# Optical block diagrams

IEEE P802.3ba, Dallas, November 2008

This contribution proposes replacement diagrams for Figures 86-2, 87-2 and 88-2.

Figure 86-2—Block diagram for 40GBASE-SR4 and 100GBASE-SR10 transmit / receive paths

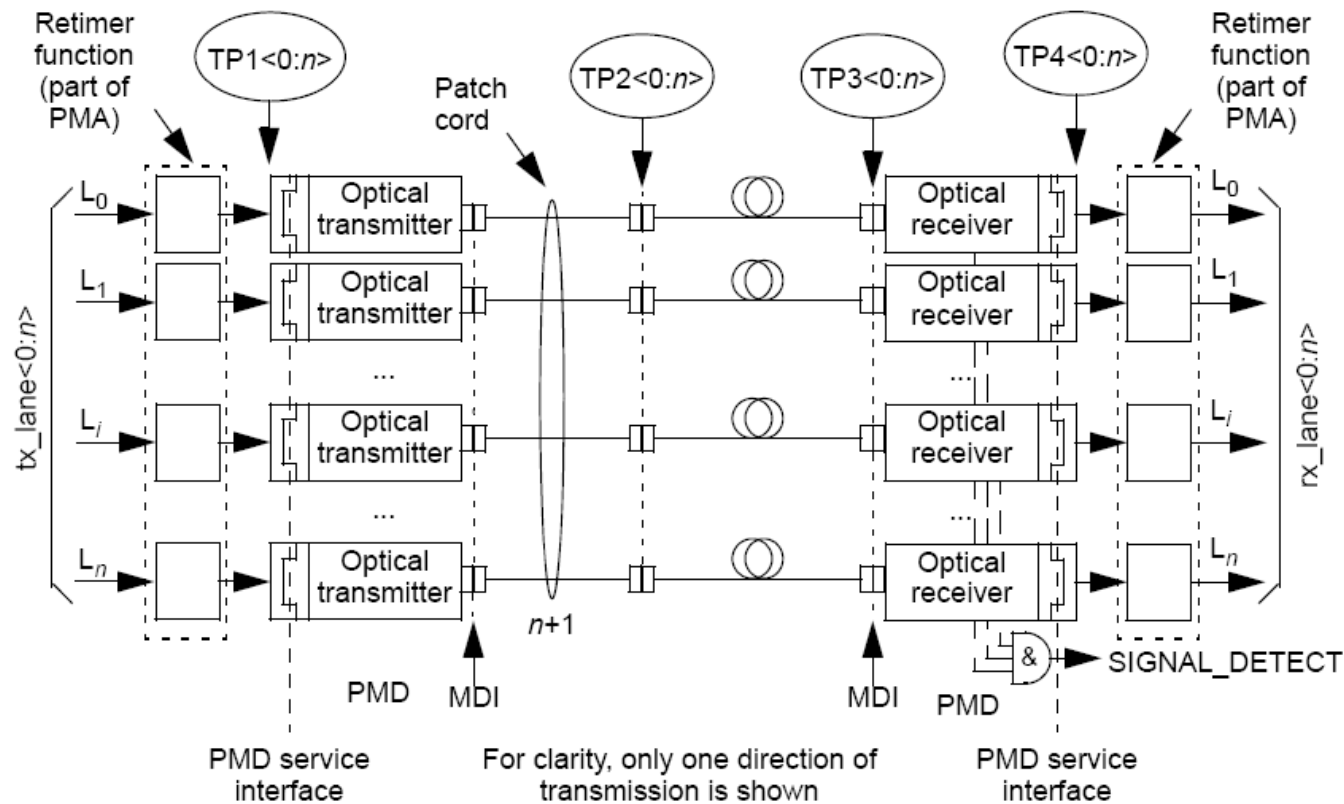
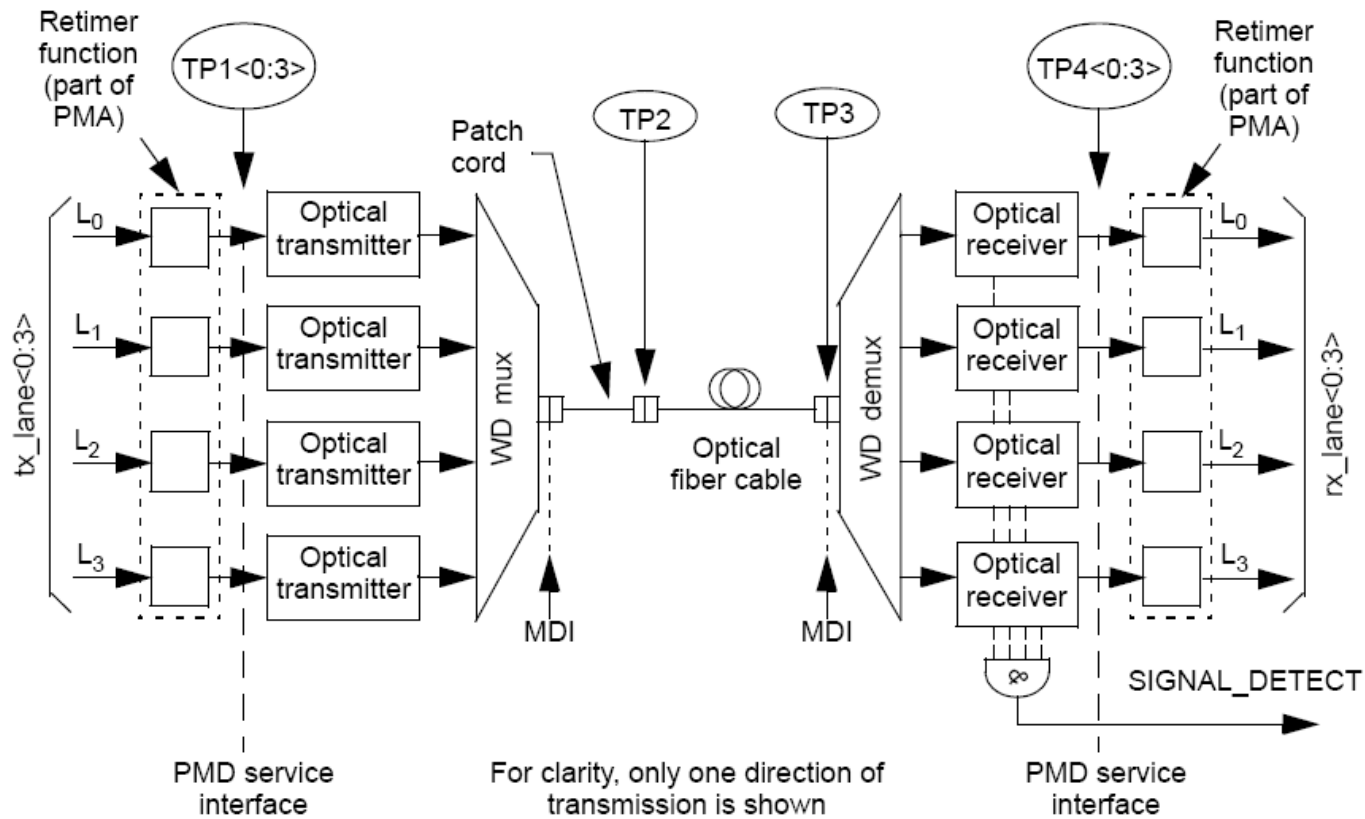
- The symbols used for optical and electrical connectors are consistent with those used in other diagrams in the draft
- The retimer labelling is consistent across all three diagrams
- The SIGNAL\_DETECT function is consistent across all three diagrams
- Notes in Figs 87-2 and 88-2 modified to remove “however, a retimer may be required to ensure compliance at test points TP2 and TP3”
- “and the electrical implementation of the PMD service interface” added to note in Fig 88-2
- The MDI is clarified in Figs 87-2 and 88-2
